Skyview Crossing at Tiffany Springs

Development Plan

NPD Committee

May 6, 2025

S Remove Conditions #9 & #28 – Off-site Water Main Stub

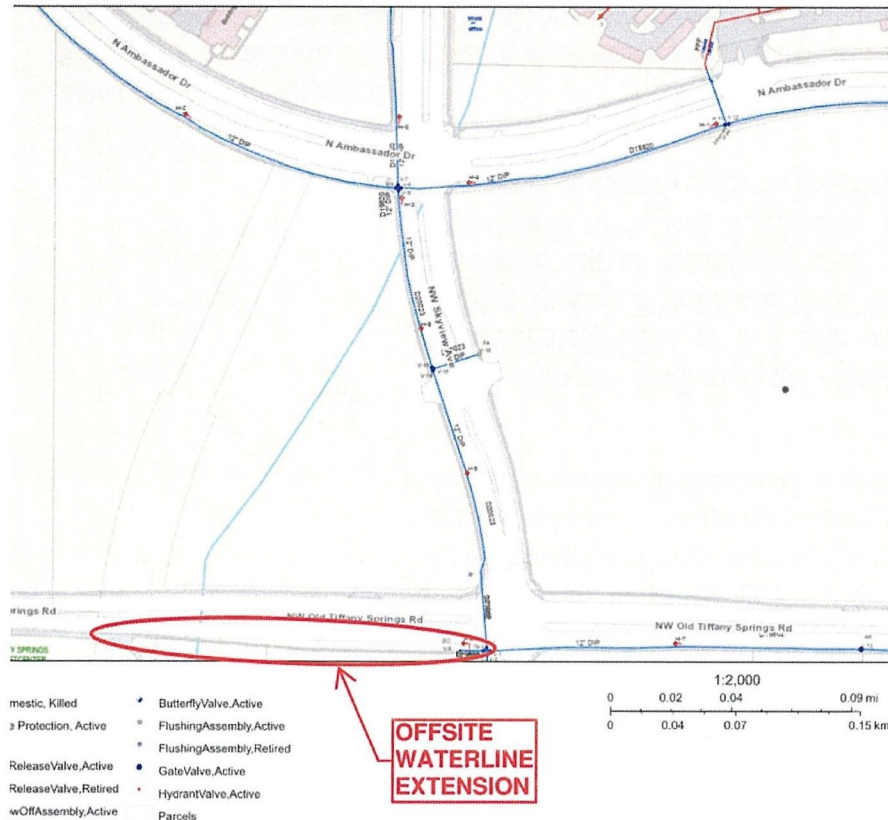
9. The applicant shall revise the plans to satisfy the Water Services Department corrections to revise the deviation note on the cover to request not installing the extension of approximately 750' of 12" DIP public water main with fire hydrants along N.W. Old Tiffany Springs Road between N.W. Skyview and the western property line. (The text in the note that this main extension would not serve this development is not accurate as the requested main extension provides a portion of the looped connection west toward the transmission main which when completed will improve the distribution system reliability and redundancy.)

28. The developer shall submit water main extension plans for the extension of approximately 750' of 12" DIP water main and fire hydrants along N.W. Old Tiffany Springs Road from N.W. Skyview Avenue to the western property limits. The water main extension shall follow all the Kansas City Water Services Department rules and regulations for water main extensions and shall be under contract (permitted) prior to building permit issuance.

Remove conditions #9 and #28 (requesting an additional 750' of off-site waterline extension, which only benefits the property to the south). The City recently re-constructed Old Tiffany and elected not to install a new waterline at that time.

In 2006, the vacant land parcel was part of a larger 74 acre rezoning and development plan approval, Case No. 6029-GP-1. There is a general condition to extend watermain connections in Ord. No. 061287. We don't think the 750' watermain extension condition is proper for our project for several reasons:

1. Skyview Crossing sits north of NW Old Tiffany Springs Road, and we intend to use existing watermain connections from the 12" watermain on the west side of Skyview, the 12" main on the south/west side of Ambassador, and the 12" main of the south side of Old Tiffany Springs. This existing watermain loop has the capacity to provide service.

2. Water Services is asking for a 750' main extension stub on the south side of Old Tiffany Springs Road on the Vacant Land Parcel. This stub would not be operational, and would not connect to the 24" watermain on the east side of I-29. The request is not proportional to the impact that Skyview Crossing has on City infrastructure.

3. The Vacant Land Parcel is not owned by us. The obligation to install this 750' watermain stub should be a condition of development on the owners of the Vacant Land Parcel.

4. We would be willing to include the 750' watermain extension in the Skyview Crossing CID to reimburse the City and/or the owner of the Vacant Land Parcel on a subordinated basis.
